January 3, 2023

Ref: Acorn Place  
Stormwater Basin Modifications

I am writing on behalf of the applicant to request a modification to the stormwater basin designs at Acorn Place. As has been documented, Basin 1 does not drain down within 72 hours during wet seasons (periods of time with repeated, frequent rainfall events). During these same wet seasons, Basin 2 holds more shallow depths of water for longer than 72 hours. It is well known that the glacial till soils on the site are restrictive<sup>1</sup>, which is why there are wetlands on the site in low lying valley areas (areas where stormwater cannot readily runoff). These wetlands exhibit similar patterns to the stormwater basins, holding surface water during wet seasons but being dry during other times of the year.

### BASIN SUBDRAIN DETAILS

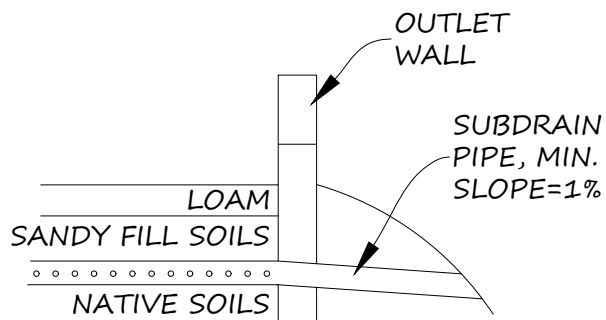
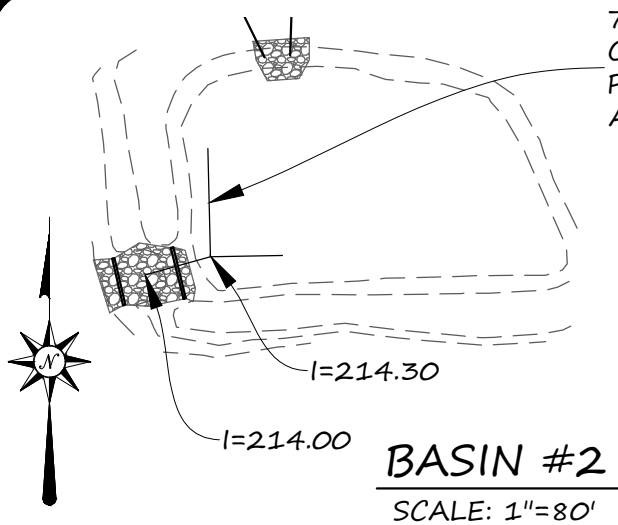
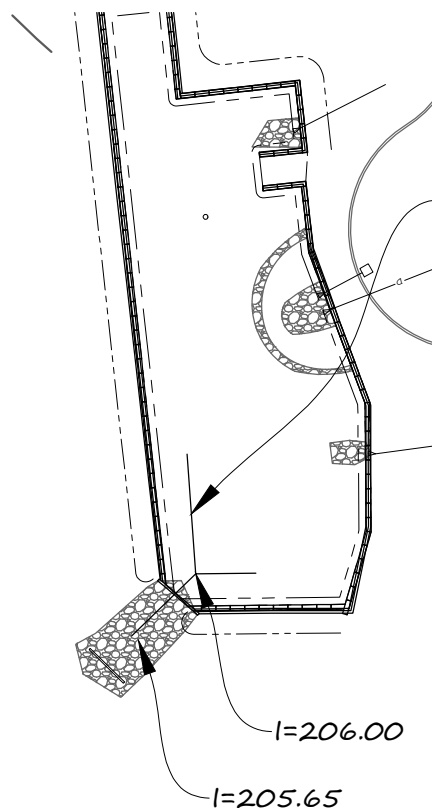
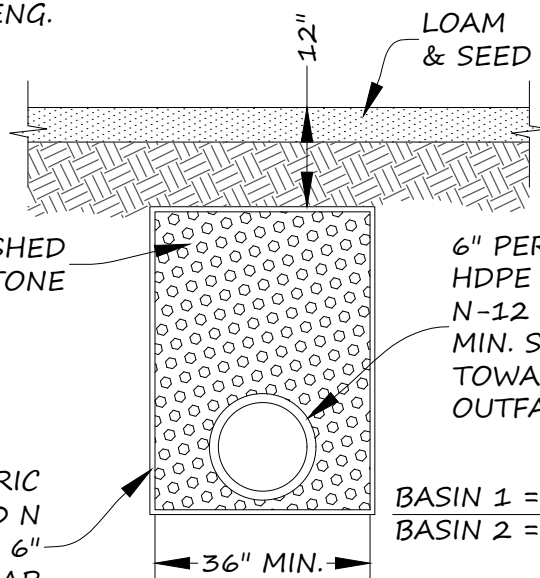
While eliminating long periods of standing water with the introduction of a small low-flow outlet at the bottom of each basin is a potential solution, it is our view that the subdrain method noted in the Handbook is likely a better solution. This would allow stormwater residence time in the basin to achieve treatment, will allow some amount of infiltration (as much as the glacial till soils can accommodate, which will vary by season) and will ensure that the basin can drain down within 72 hours. Each of the two basins has a substantial thickness of imported permeable fill soils above the underlying glacial till at the bottom of the basin. It is our recommendation that a subdrain be placed within this permeable fill layer per the enclosed details, which would allow for the slow and gradual release of infiltrated water over a period of days, allowing the basins to draw down in a reasonable time frame.

75 LINEAR FEET OF SUBDRAIN PER DESIGN ENG. APPROVAL.

### BASIN HEADWALL MODIFICATION DETAILS

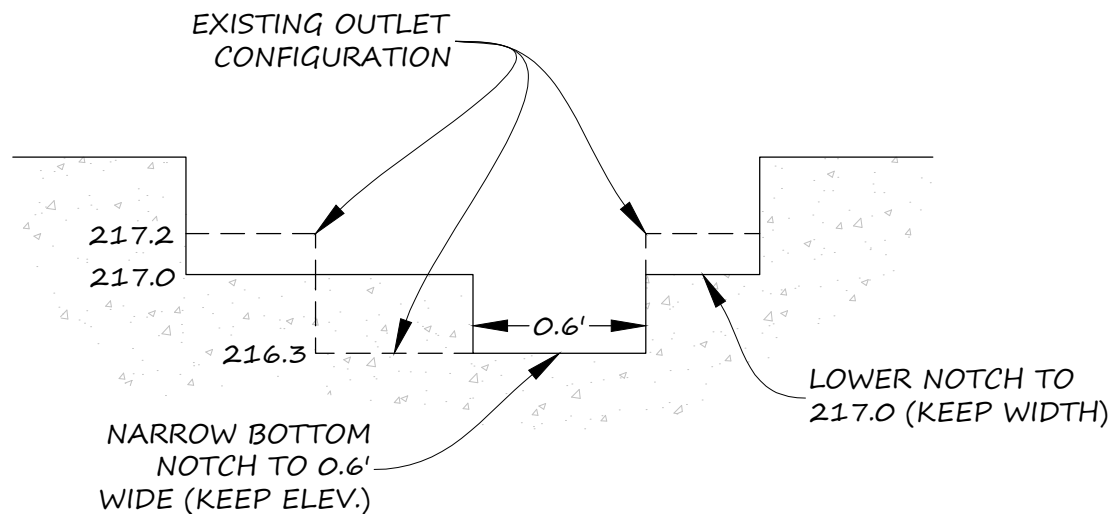
For Basin 1, the elimination of infiltration in the Hydrocad model only resulting in an increased peak rate of runoff in the 100-year storm. Thus, additional low-flow outlets are proposed to change the stage-discharge model to allow all peak rates to be lowered. In order to maintain the Water Quality Volume storage within the basin (4,332 c.f.), three additional 4" diameter cores are proposed to be added to the headwall at elevation 210.80, which results in a raw standing volume of 4,981 c.f. within the basin. These three new outlets will be 0.2 feet lower than the existing low-flow outlet, reducing the depth of standing water in the basin to 0.3 feet. This modification yields the following as indicated in the attached Hydrocad model:

For Basin 2, the elimination of infiltration in the Hydrocad resulting in small peak rate increases in all storm events. Thus, to accommodate the revised stage-storage relationship with no infiltration included, the outlet notch is proposed to be modified per the detail in attachment C. This modification yields the following as indicated in the attached Hydrocad model:
